RECEIPT DATE: 1/18/2019 **ONSITE SEWAGE DISPOSAL SYSTEM** P 564734
 APPROVAL DATE: 4/22/19 KM **PERMIT: CONSTRUCTION** A _____
 PROPERTY ADDRESS: 13825 Mill Creek Court Clarksville, MD 21029
 SUBDIVISION: Crawford LOT: 21 TAX ID: _____
 CONTRACTOR: South Carroll EMAIL: _____
4410 Salem Bottom Rd
 CONTRACTOR ADDRESS: Westminster, MD 21157 PHONE: 410 875 4197
 PROPERTY OWNER: NVR Inc EMAIL: _____
 OWNER ADDRESS: 9720 Patuxent Drive Columbia PHONE: 410-379-5956
 SEPTIC TANK SIZE (GALLONS): 1500gal TANK MANUFACTURER: Mayer Brothers
 PUMP MODEL: Hoot 600 BNR PUMP SIZE E152 PUMP TANK CAPACITY: 1500gal

Hello Kristy everything looks good. However, we have a few minor changes on your OSDS plans. They must be revised and resubmitted for review. Your building permits will not receive building permit approval until the OSDS plans have been approved. I will list them in order of lot.

BAT INSTALLATION SITE PLAN

CRAWFORD SUBDIVISION
LOT 21 (13825 MILL CREEK COURT)
PLAT No. 24600-24607

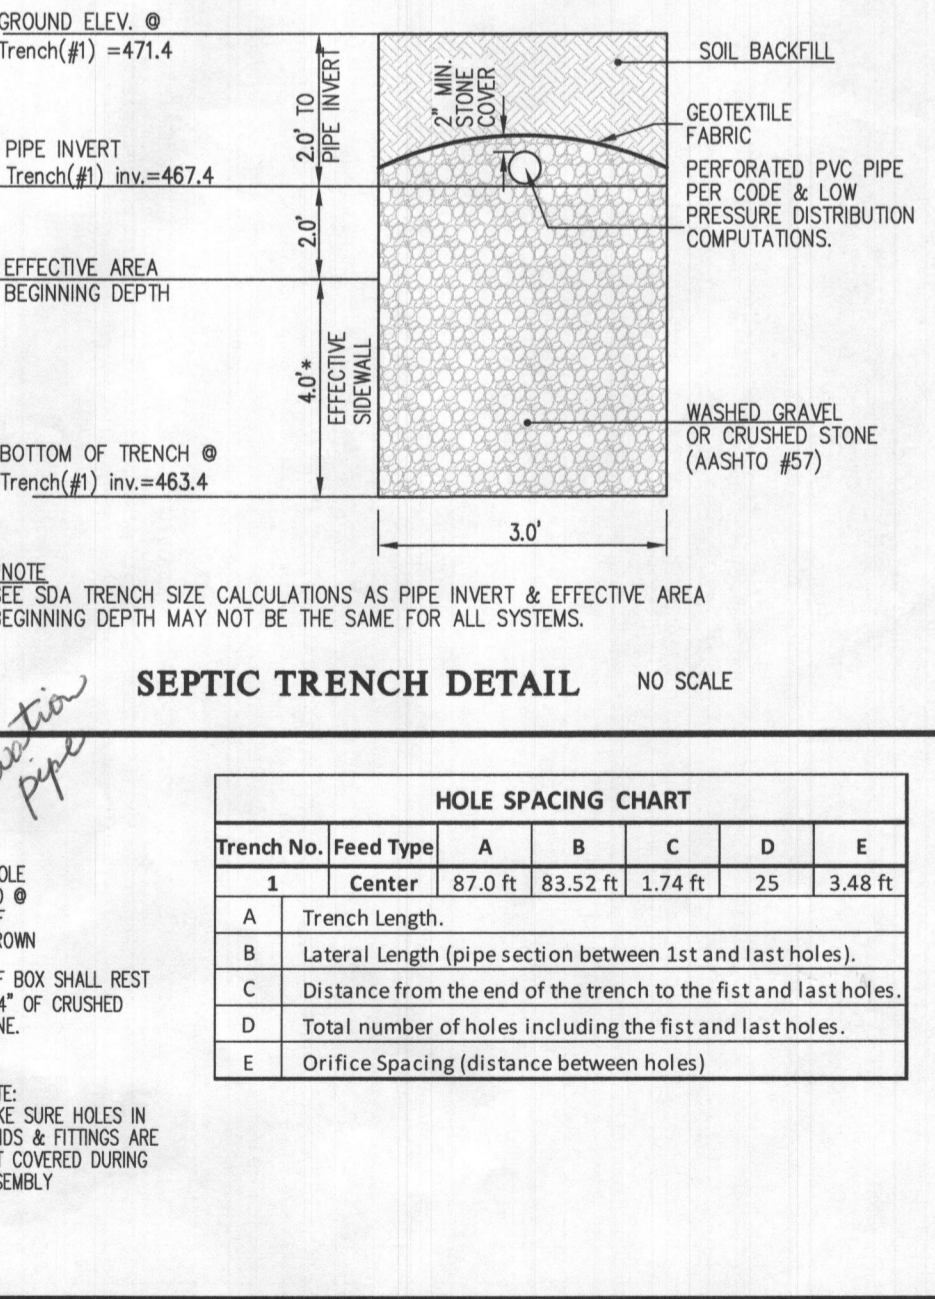
Yes, with the 2-45 bends TDH goes to 22.0, see attached pdf. It is slightly over the curve for the pump selected.

Thanks for your email. Would you be able to run the calculations adding in the 2x 45 degree bends? Ideally we want to keep the force main close to the septic area to avoid it being hit during any future digging in the yard.

Adding the 2-45 degree bends will increase friction enough to require a different pump. They can use a larger radius if they are cold bending and this would not effect the pump size.

The force main shows a large bend before it reaches the 90 degree bend at the trench. The contractor cannot bend the pipe so sharply- can they put in 2x 45 degree bends? Does this change the friction enough to require a different pump?

Yes, they could use the Zoeller Model N153 (115volts, 1/2 hp) or Zoeller Model E153 (230volts, 1/2 hp), depending on what they have the electric set up for.

SEPTIC TRENCH DETAIL

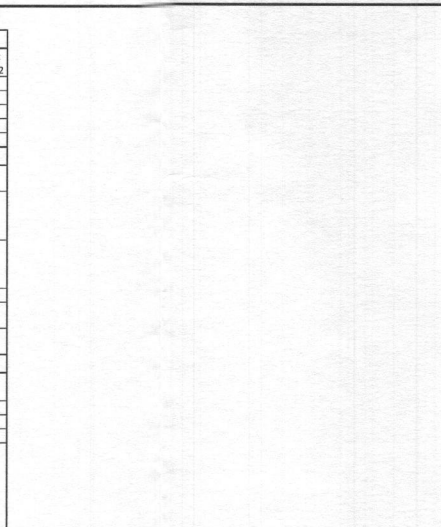
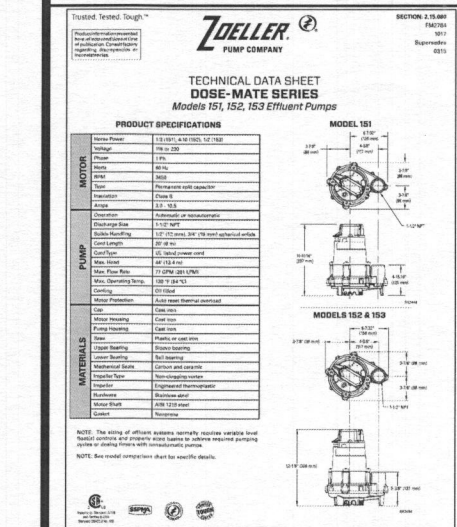
1. The pipe invert on your septic trench detail should be at 2 feet. We are recommending using 2 feet to obtain the most efficient design. Please make calculation adjustments needed. Revised pipe invert to 2 feet. Updated Trench Detail, LPD Calculations, Profile & Plan accordingly.
2. There is a 45 degree bend at the end of your trench. Please show the perforations at this point in the trench detail. We don't want the perforation to be covered by the connection of the two pipes.

3. We need to add an observation pipe at the end of your trench. Please show in trench detail on OSDS. The observation pipes are shown in the typical trench detail. We added a turf box to detail.

4. Also we need to show the friction head loss for the union disconnect. This "coupling" is accounted for in the LPD Distribution System Calculations (highlighted on attached 11x17)

5. Please recalculate and make sure all calculations are correct. Updated spreadsheets.

6. Please state the time dose setup for the pump tank. This number (6 doses at 125 gallon/dose) is shown in the Pump Chamber Volume Calculations (highlighted on the attached 11x17)

Added a note to the typical trench detail "make sure holes in bends & fittings are not covered during assembly"
